ADDRESS: 415-17 AND 419 S 15TH ST

Proposal: Construct rooftop and rear additions

Review Requested: In Concept

Staff Contact: Allyson Mehley, allyson.mehley@phila.gov

AERIAL PHOTOGRAPH – PROPOSED ADDITIONS

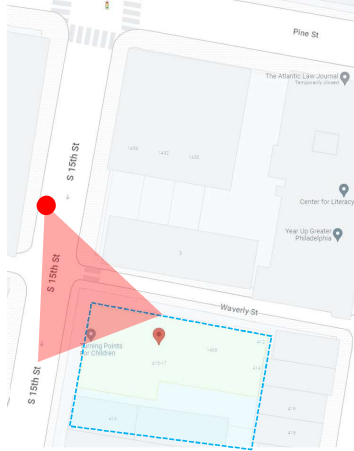
- The proposed size and massing of the fourth-floor addition on 415-17 S. 15th Street at the corner of S. 15th Street and Waverly Street does not meet Standard 9. The addition will be visible from the public right-of-way and remove a portion of the mansard roof. A fourth-story addition could be added to this level and meet Standard 9. To do so, it would need to be set back from the mansard and edge of the building along Waverly Street.

- The proposed two-story connector between the two properties along S. 15th Street does not meet Standard 9. This wing of the building at 415-417 S. 15th Street maintains its original form that dates to the circa 1860 construction. The proposed two-story connector would alter the historic integrity of this wing and remove a section of the mansard on the main block of the building.

- The proposed fourth-floor addition on 415-17 S. 15th Street at the corner of S 15th Street and Waverly Street could meet the Roofs Guidelines with proper setbacks.

STAFF RECOMMENDATION: Approval, provided the rooftop additions are set back from the front of the building and alterations to the mansard are limited, pursuant to Standards 9, 10, and the Roofs Guideline.

PROPOSED ADDITIONS

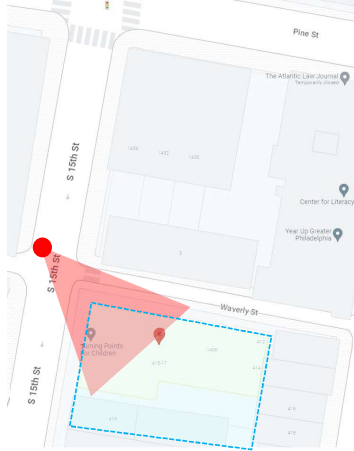
- If the fourth-story additions are set back from the corner of S. 15th Street and Waverly St, they could meet Standard 10.
 - The proposed two-story connector along S. 15th Street does not meet Standard 10.
